Project:	Highways England Spatial Planning Arrangement	Job No: 60600479 DM014.005
Subject:	South Caldecotte, Audit of Revised VISSIM model	
Prepared by:	Jay Shah	Date: 02/04/2019
Checked by:	Javier Pardo	Date: 04/04/2019
Verified by:	Phil Arnold/Liz Judson	Date: 05/04/2019
Approved by:	John Alderman	Date: 26/04/2019

This technical note consists of a modelling audit of the revised Kelly’s Kitchen Roundabout (A5) base VISSIM models, provided by BWB to support the planning application of the proposed South Caldecotte development at Milton Keynes. The audit was carried out based on WebTAG guidance and best practices based on the VISSIM Model Audit Process (VMAP) from Transport for London.

Figure 1: Screenshot of overlapping vehicles

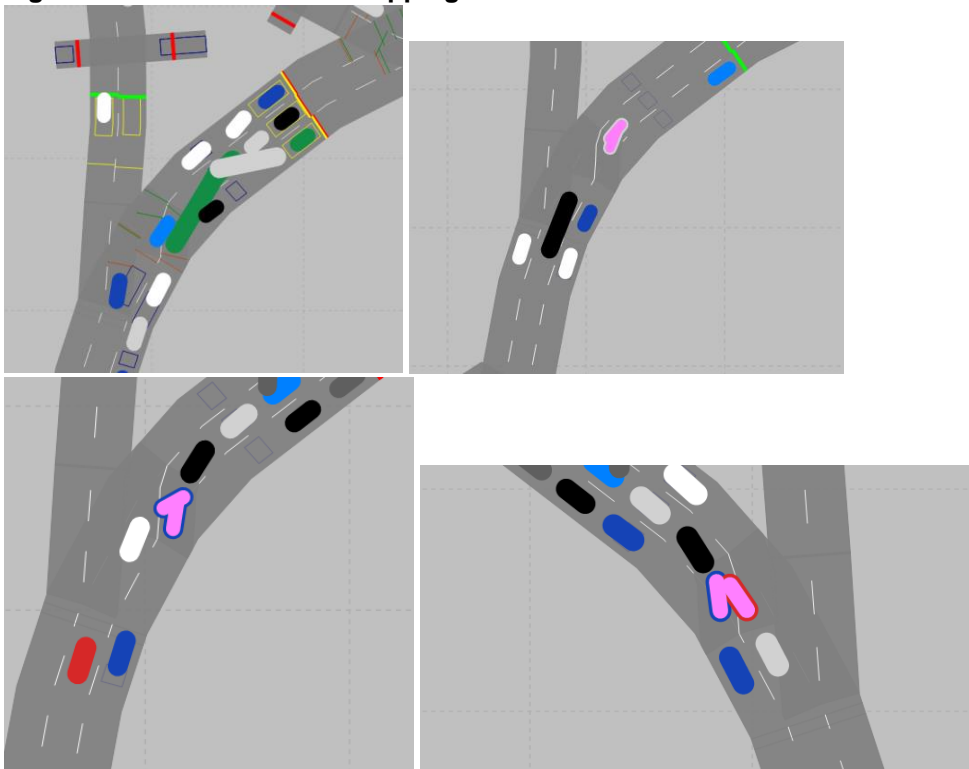
There are occasions when the vehicles overlap each other on the roundabout. The pictures below shows a few instances of the occurrences. This problem has been improved when compared to the previously submitted models, but addressing further improvements to avoid these overlaps would be ideal. The likely impact would be **MINOR**.

Figure 2: Conflict Area error.

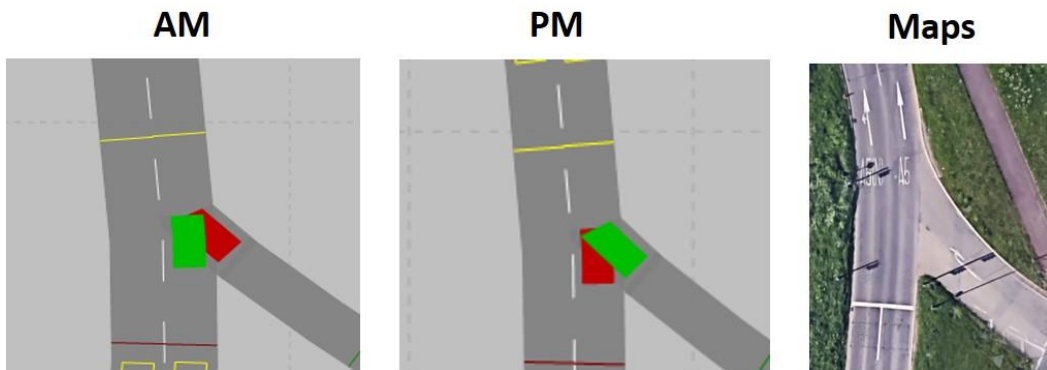
The conflict area coding of merge of Link 28 (Northbound link) and Link 39 (Side arm link) in the PM Peak model is inconsistent with AM Peak model. This might cause unnecessary waiting of vehicles on Link 28 whenever there is a congestion or queue on north of the merge towards the signals at Roundabout. It is ideal to have consistency between AM and PM models. This inconsistency is not justified in the LMVR. This might have an impact on the Validation and Calibration.

The impact would be **MINOR**.

Figure 3: Desired Speed Decision coding error.

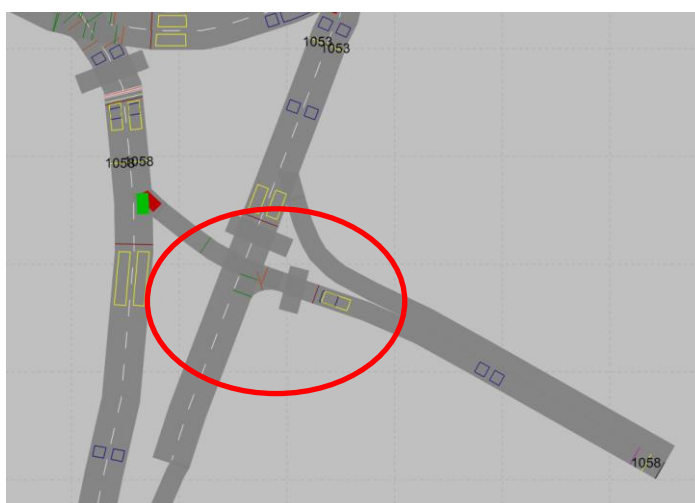
The Desired Speed Decisions are missing on Link 5 (2-lane segment in southbound direction) for the Left turning vehicles from Link 37 (Side arm). The vehicles on Link 37 drive at a desired speed of 30 mph as coded. Link 5 should have a speed of 60 mph coded. This will reduce the overall driving speed on this Arm in Southbound direction and have an impact on the Journey Time Results for the Journey Time sections, especially those which end on Link 27 (1-lane segment in southbound direction). While this might or might not result in a significant change to the results of the Base Year models, it could impact the Forecast Year models where there could be a vehicular growth on this Link. The likely impact of this issue is considered to be

MEDIUM.

Figure 4: Desired Speed Decision coding error.

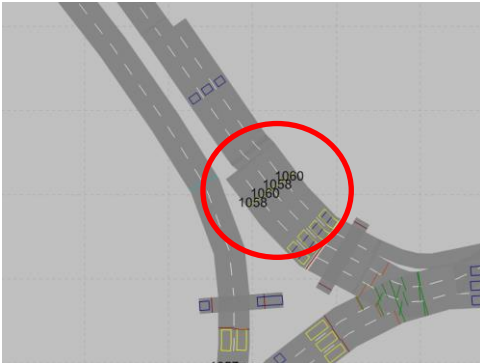
The Desired Speed Decisions on Link 33 are inconsistent between different lanes. Lane 2 and Lane 4 have Speeds of 20 mph compared to Lane 1 and Lane 3 which are coded as 30 mph. This will mean that the vehicles using Lane 2 and Lane 4 will drive on the roundabout at a speed less than the desired speed and might impact the overall capacity of the Roundabout. The likely impact would be **MINOR**.

Figure 5: Desired Speed Decision coding error.

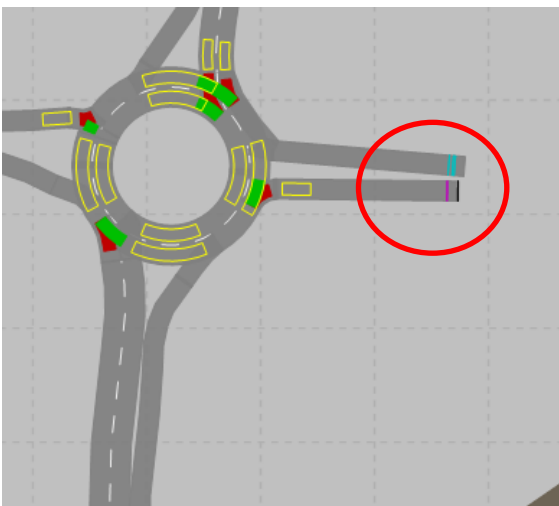
The Figure 5 shows that there is no Desired Speed Coded on Link 32 which would mean that the Vehicles originating from Link 32 will drive on the Default Speed of 60 mph which is higher than the desired speed of the roundabout (40 mph) as coded on other approach arms to this roundabout. The flow from this link is negligible but it is advisable to correct this with a Desired Speed Decision coding. The likely impact would be **MINOR**.

Figure 6: Reduced Speed coding error.

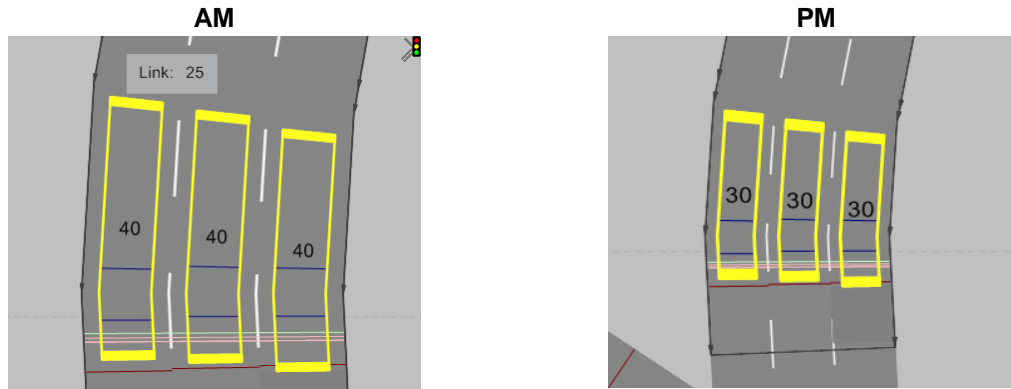
The Reduced Speed Areas should have consistency between the AM and PM peak models. Link 25 (Approach arm to the roundabout from North – V10 Brickhill Street) shows some inconsistency with the coded speeds in the Reduced Speed Areas. There is no reason given for this within the LMVR. The likely impact would be **MINOR**.

Figure 8: Conflict Area Inconsistency.

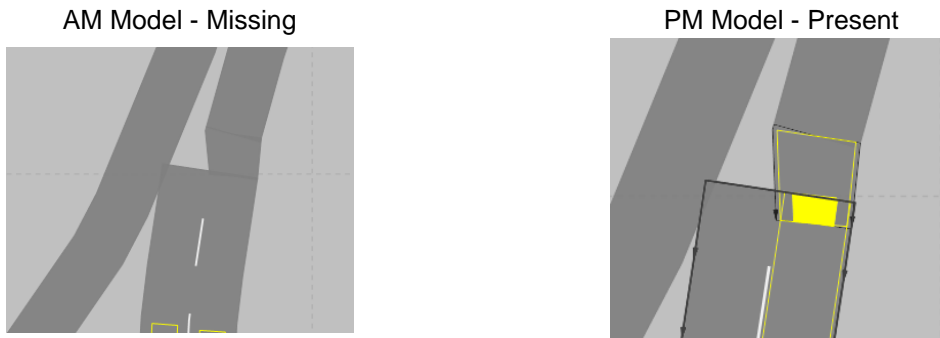
Conflict Area No. 46 is coded as Passive for Link 10062 and Link 46 and is present in the PM Model but not found in the AM Model. This correction will have no impact but it is ideal to have consistency between the AM and PM models.
